**COUNTY OF SAN MATEO  
PLANNING AND BUILDING DEPARTMENT**

**SUBJECT:** EXECUTIVE SUMMARY: Consideration of a Non-Conforming Use Permit, Coastal Development Permit, and Design Review Permit, pursuant to Sections 6133.3b, 6328.4 and 6565.3 of the San Mateo County Zoning Regulations, respectively, to allow construction of a new 1,469 sq. ft. one-story single-family residence with a 448 sq. ft. attached two-car garage on a legal 3,056 sq. ft. non-conforming parcel, located on The Alameda in the unincorporated El Granada area of San Mateo County. The project is not appealable to the California Coastal Commission.

County File Number: PLN 2019-00368 (Moules)

**LEGEND: LANDSCAPING**

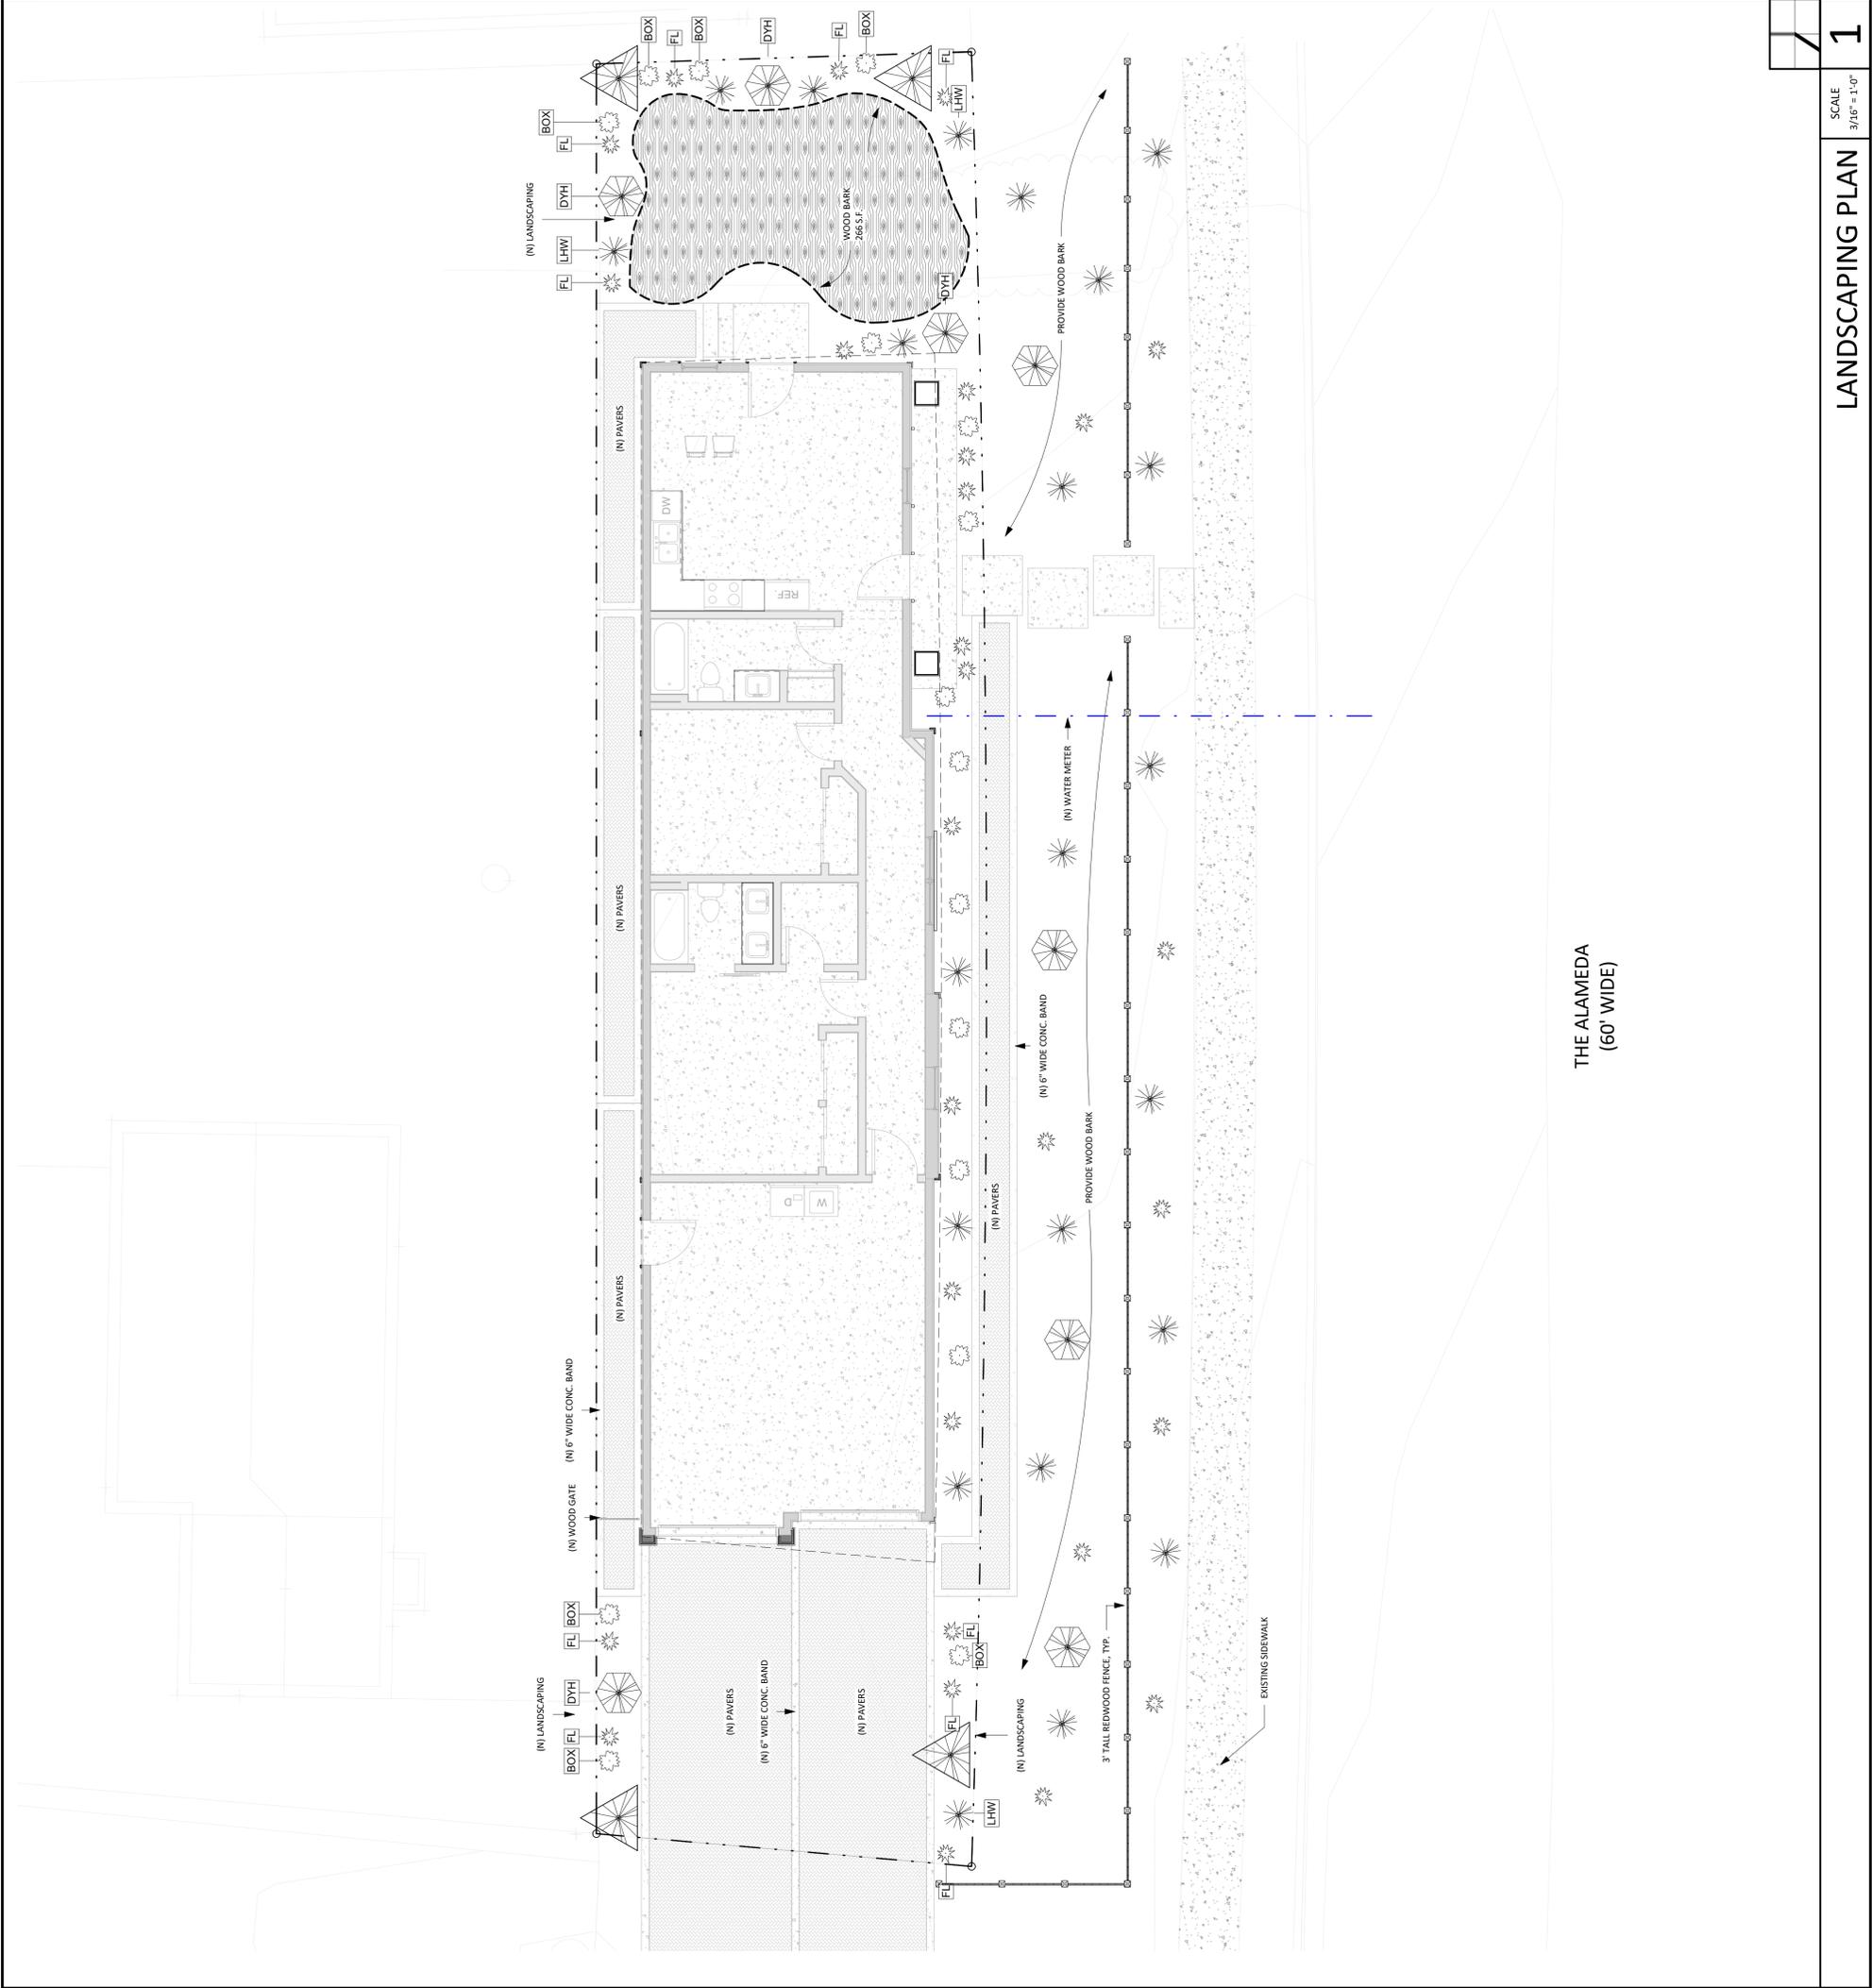
- b. On the North elevation, stop the wrapping stone facade at gridline E.
  - c. On the South elevation, update the landscape plan to include landscaping in the area between the permeable pavers and the existing sidewalk.

- d. On the North elevation, in the landscape plan, indicate a gate at the walkway.
  - e. Coordinate the civil sheets with Sheet A2.12.
  - f. On the North elevation, provide facade articulation by breaking up the existing horizontal design elements with vertical board and batten siding under the main roof gable.
